Service Bulletin

Subject: Information on Fuel Tank Replacement

Models: 2006-2008 Saturn Ion

1. Saturn Ion Fuel Fill Hose
2. Chevrolet Cobalt Fuel Fill Hose

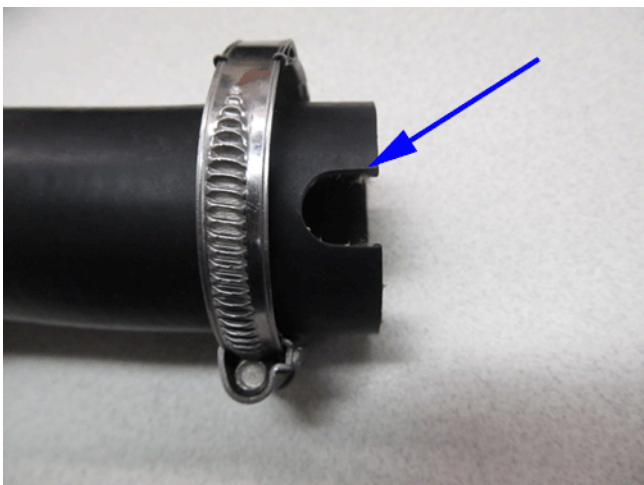
When a dealership replaces a fuel tank on a Saturn Ion, they **MUST** also replace the fuel filler hose with one from a Chevrolet Cobalt.

This is because there is an interface issue with current Saturn Ion fill hose alignment feature position notch. The alignment feature position is 180 degrees different for new service tank replacement.

1. Remove old fuel fill hose.
2. Align both hoses side by side.

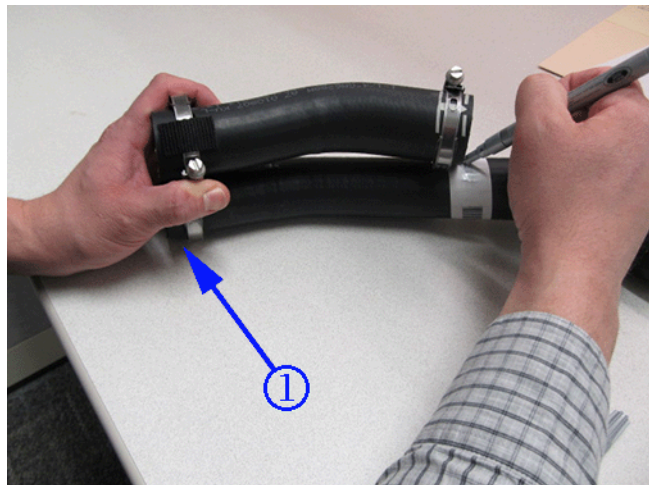
The fuel fill hose (P/N 20757866) will be too long and must be trimmed by following the procedure below.

1. Both notch ends of hoses on same side.
3. Using a paint pen or equivalent, mark where the original hose ends so that both hoses are the same length starting with the notched ends of the hoses.
4. Cut the hose opposite of the side with the notch in one end.
Important: When cutting the hose, be sure the cut is as straight as possible. Failure to cut the hose straight could result in leaks.
5. Transfer the clamp on the newly cut hose.
